Catherine Field Primary School Mod 2 Additional Information – 19th November 2020

SECTION 4.55(1A) MODIFICATION APPLICATION, NEW CATHERINE FIELD PUBLIC PRIMARY SCHOOL (SSD 9477 – Mod 2) – ADDITIONAL INFORMATION

We refer to the Department of Planning, Infrastructure and Environment (DPIE) request for additional information dated 10th November 2020 relating to matters raised by Camden Council. The following information re-states the matters (in *italics*) and provides a response to each.

PLANTING PLAN
1:200

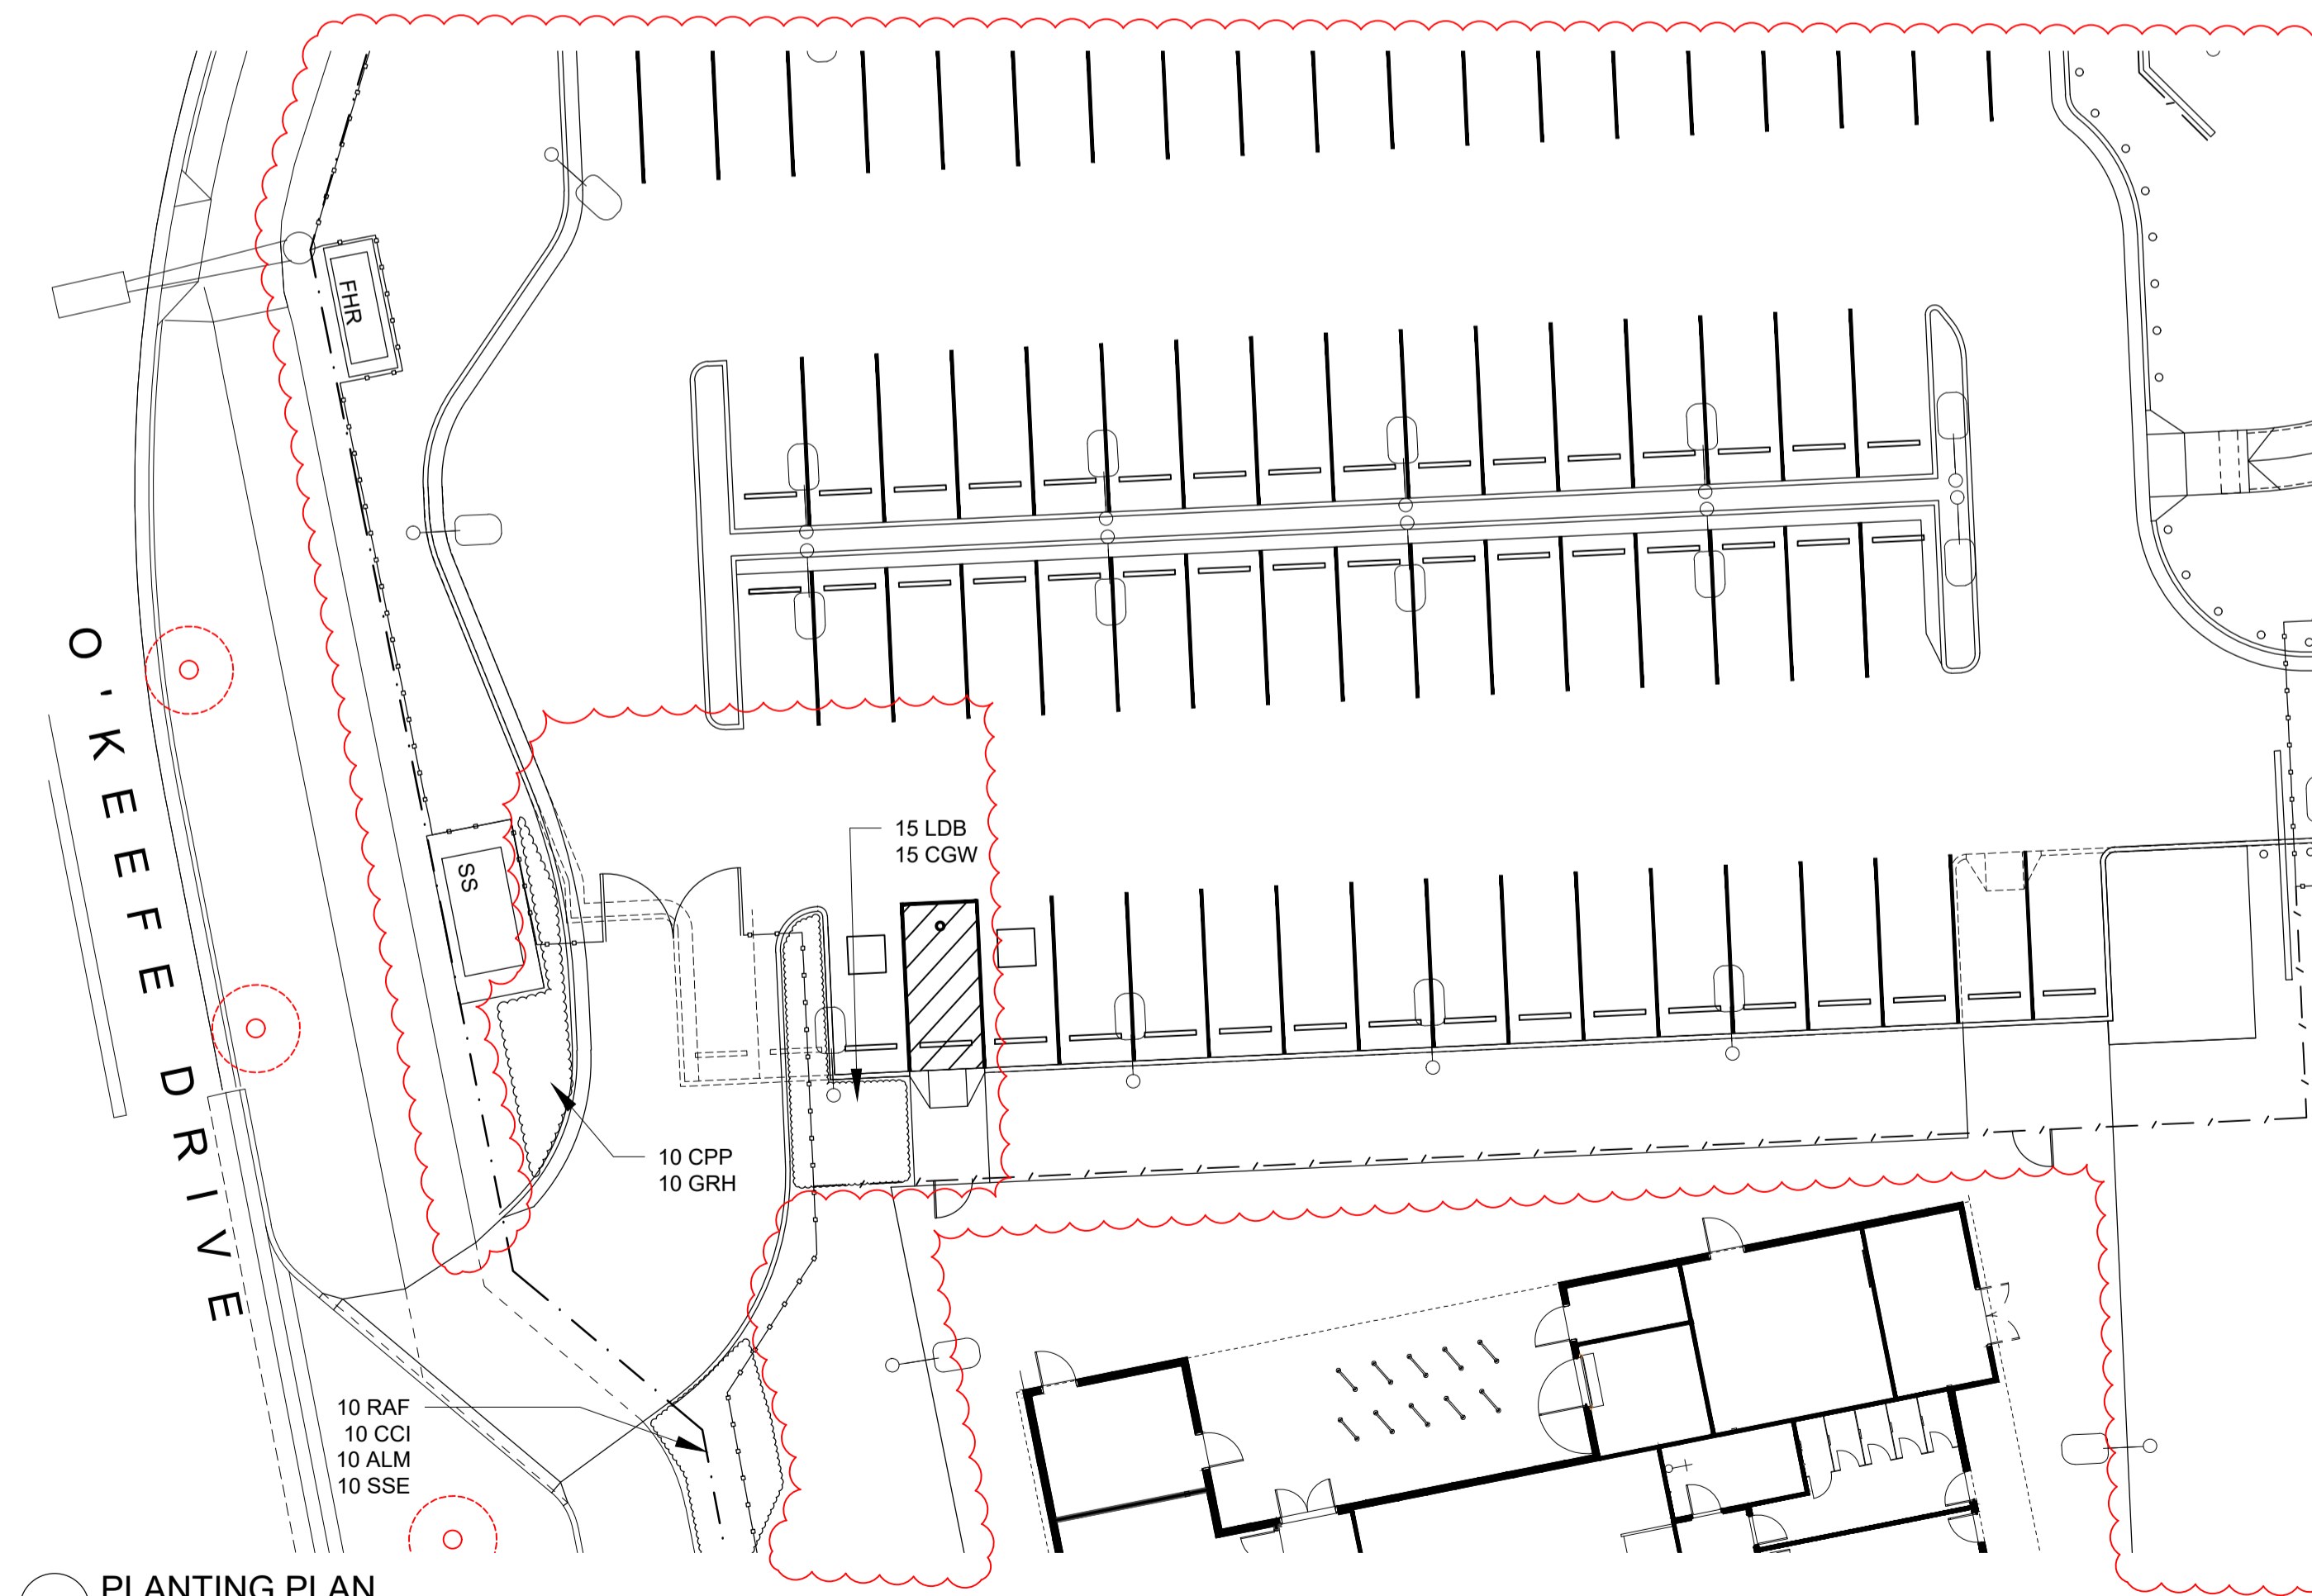
2. *Sightlines at the interim access shall be assessed – the driveway is angled and setback, also it's not clear if trees will be planted adjacent to the driveway*

7. *The landscape plans submitted with the application show the removal of all street trees along O'Keefe Drive and no street trees along the southern perimeter road. There appears to be ample opportunity to plant street trees in the unencumbered areas of these road verges. Street trees should be avoided near the entrance and exit of the kiss and drop / interim car park to avoid blocking sight lines.*

Street trees will not be planted either side of the connection point of the temporary access with the bus and special needs student drop off area. Mass planting will occur within the school site including along the fence line of O'Keefe Drive. Sufficient sightlines will be afforded to vehicles entering and exiting the car park.

As mentioned on page 1 street trees will not be planted either side of the connection point of the temporary access with the bus and special needs student drop off area. The depth of the bus and special needs student drop off area and the Council request for 3.5m wide footpaths in the area eliminates the ability to provide street trees in this location. Mass planting will occur within the school site including along the fence line of O'Keefe Drive. It is also noted that once the interim access is removed two street trees could be reinstated at the northern end of O'Keefe Drive.
